Map Correction-Field Verification

Drain Number: #264

Drain Name: Cheswick: Cheswick Sec. 4 Arm Change +/-: -14'

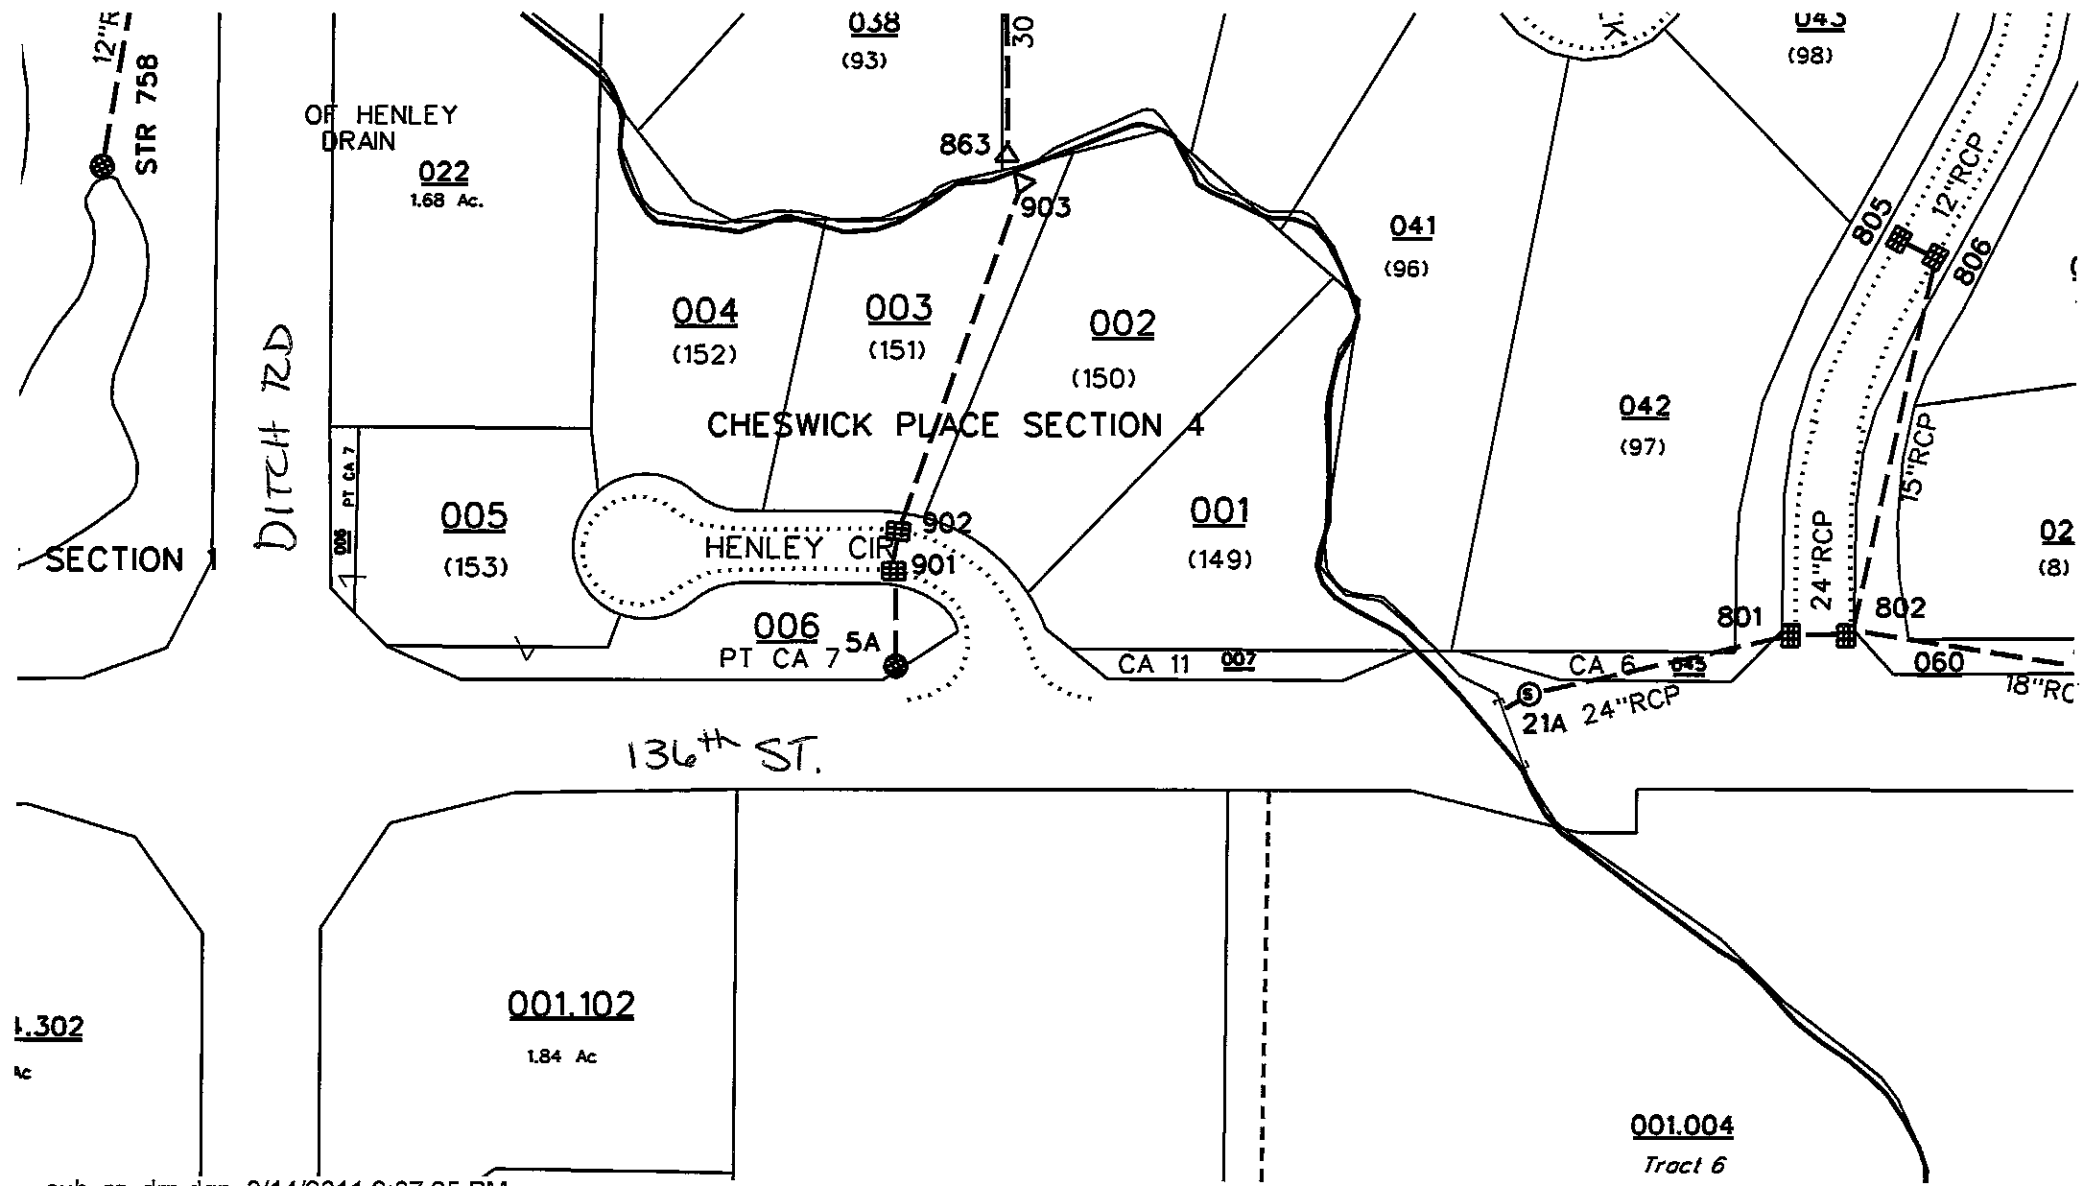
The City of Carmel widened 136th St. between Ditch and Springmill Rd. (See plans by DLZ with Project #04-07) (Sheet 6)

The project removed STR 900 and set new inlet #5A 14' upstream of the existing structure. Therefore, this change removed 14 feet of 12" RCP.

New Length: 1165

See Plans By: DLZ Proj. 04-07, Sheet 6

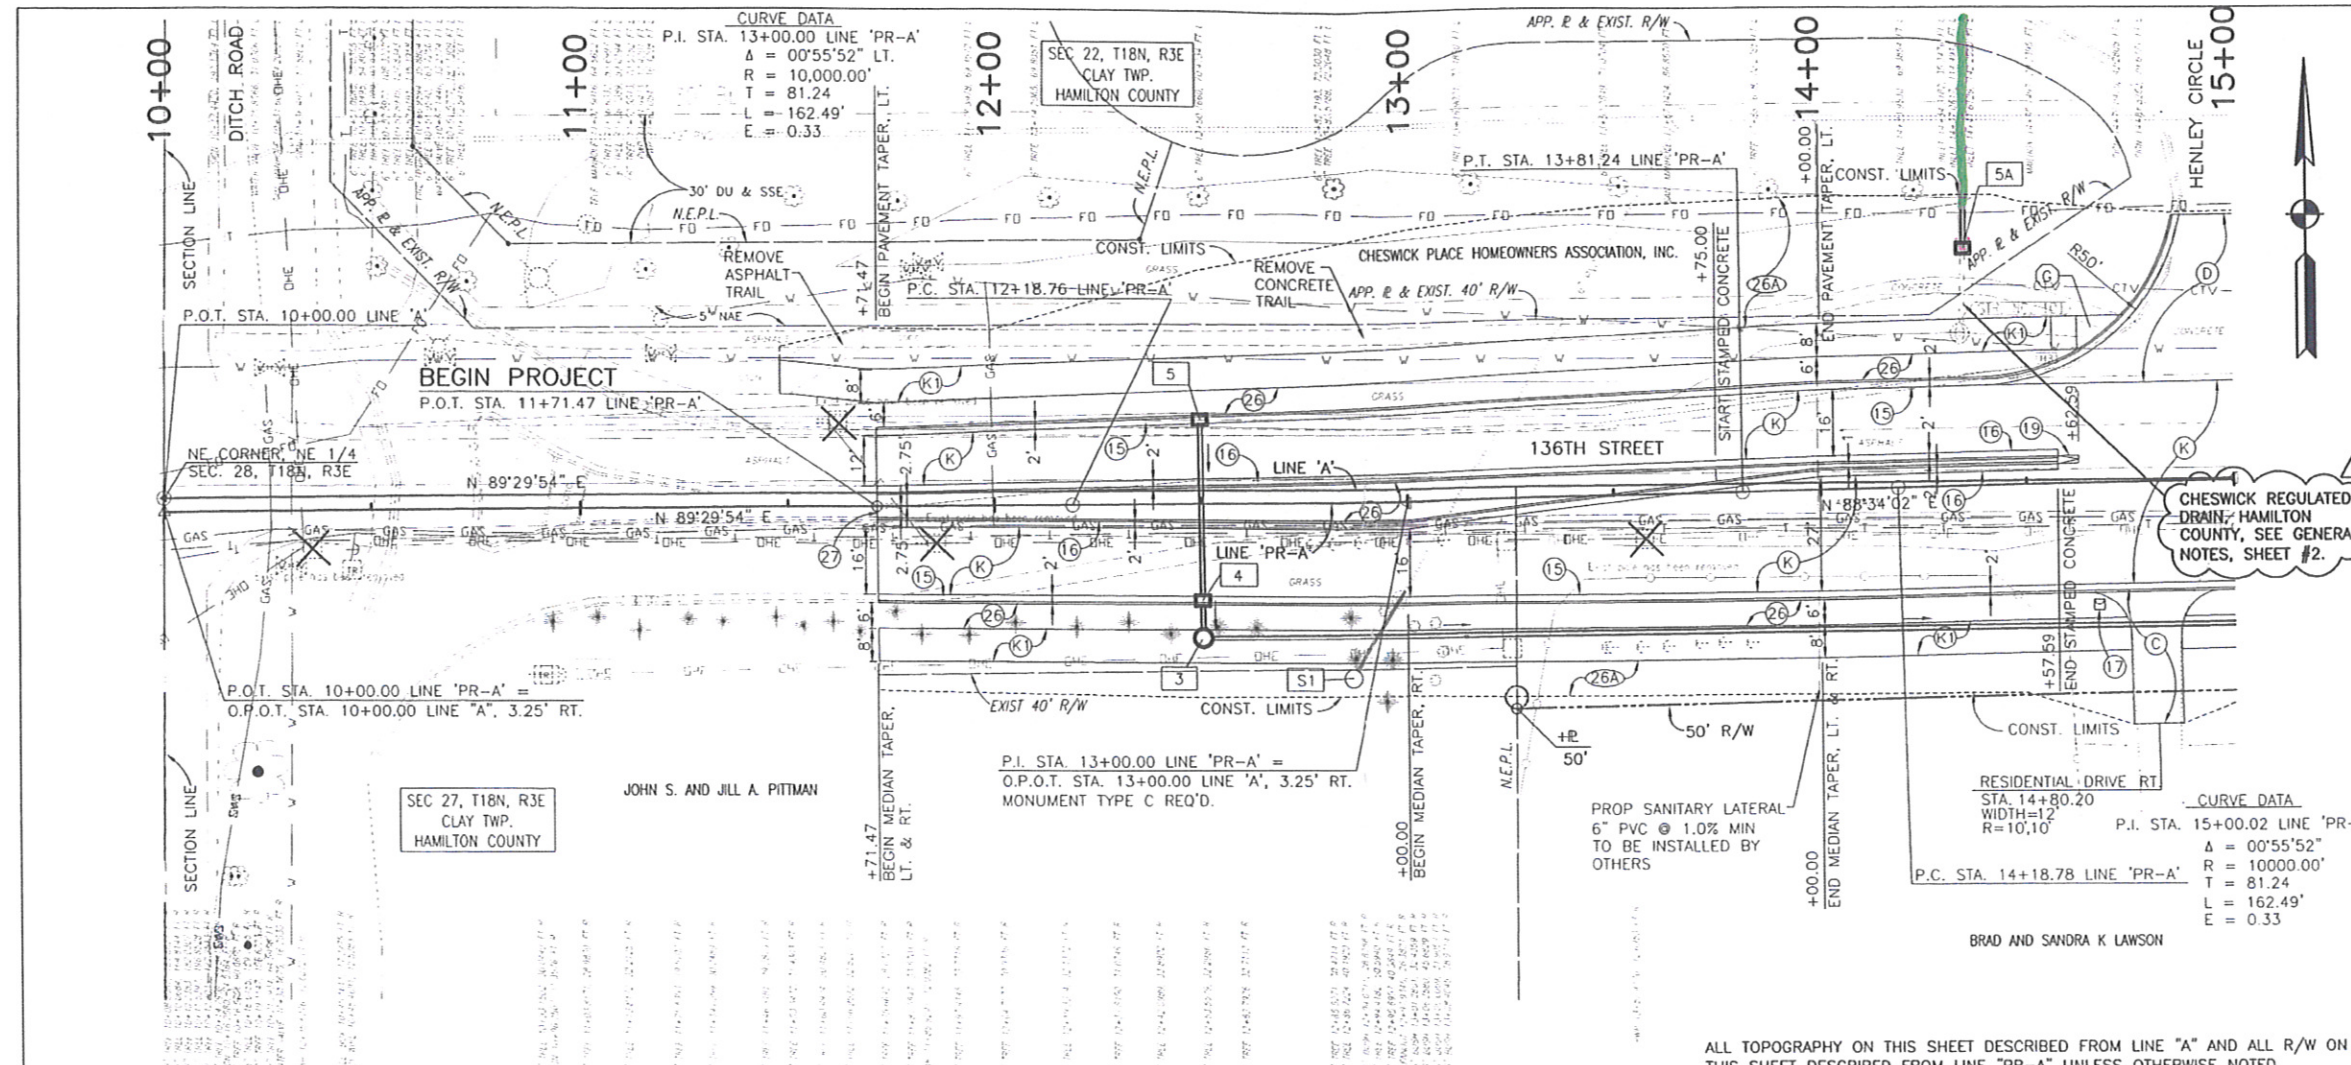
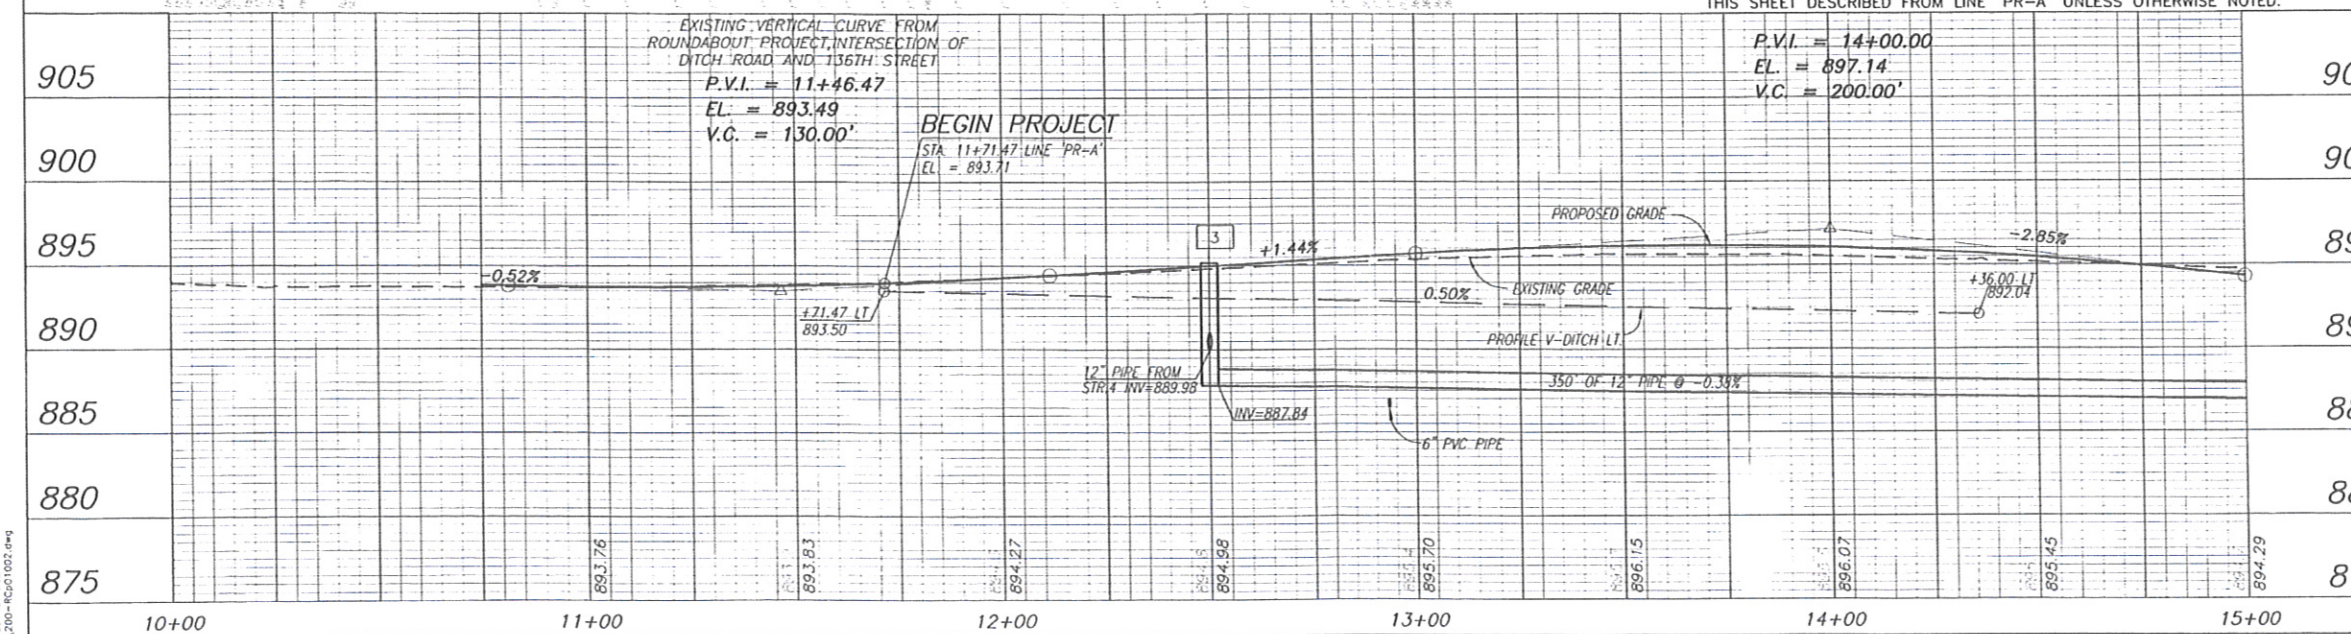
- 3 12+50, 31.87' RT. STR. NO. 3
MANHOLE TYPE C-4 & 350' OF 12" PIPE REQ'D
- 4 12+50, RT. STR. NO. 4
CATCH BASIN TYPE K-10 W/ CATCH BASIN HOOD & 9' OF 12" PIPE REQ'D
- 5 12+50, LT. STR. NO. 5
INLET J-10 & 43' OF 12" PIPE REQ'D
- S1 12+98, 26' RT STR. NO. S1
SAN CLEANOUT STR & 23' OF 6" PVC PIPE REQ'D
RELOCATE CLEANOUT TO 12+86, 45' RT. ADJUST TO GRADE. SEE SHEET #20.
- 5A 14+36, 52' LT STR. NO. 5A
INLET TYPE F-7
PROVIDE 8' OF 12" PIPE & CONNECT WITH EXISTING 12" PIPE

EXISTING STRUCTURES
REMOVE INLET & 28' OF 12" RCP
